RE: Notice of Work Complete
2577 Main St,
Glastonbury, CT 06033
Sprint Site #: NV2.5_CT43XC822

Subject: Modification Inspection Report

SBA Designation: SBA Site Number: CT46126-A
SBA Site Name: Glastonbury-Main St.

Site Data: 2577 Main Street, Glastonbury, CT 06033
Latitude: 41.7144° Longitude: -72.6130°
130' Self Support

MODIFICATION SCHEDULE

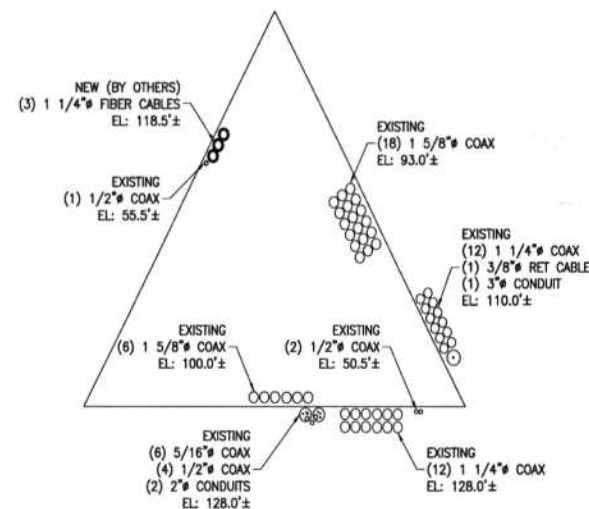
Byrce Patk

NOTES CORRECT LOCATIONS!

☒ EOR has reviewed the issues noted and passed the as-built condition(s).

SHEET TITLE
DIAGONAL REPLACEMENT DETAILS

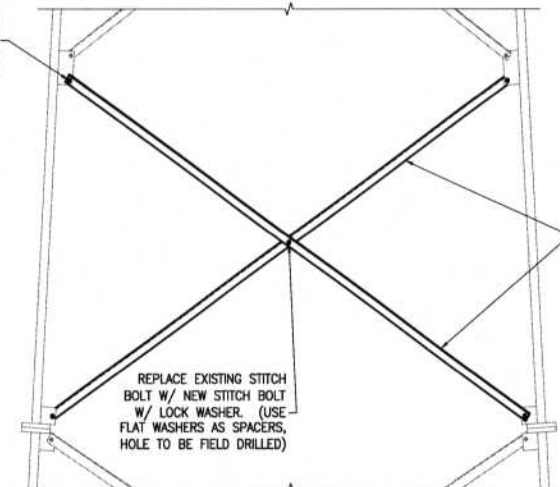
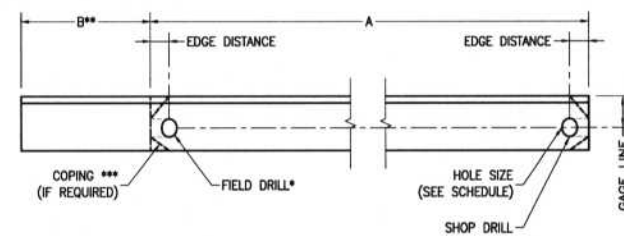
NO COPING NEEDED &
 NO COPING VISIBLE.

NOTE: ALL INSTALLED & IN GOOD CONDITION

SECONDARY INSPECTION
☒ EOR has reviewed the issues noted and passed the as-built condition(s).
☐ GC has revisited the site and corrected the punchlist items shown. Documentation showing these corrections has been received by the EOR.
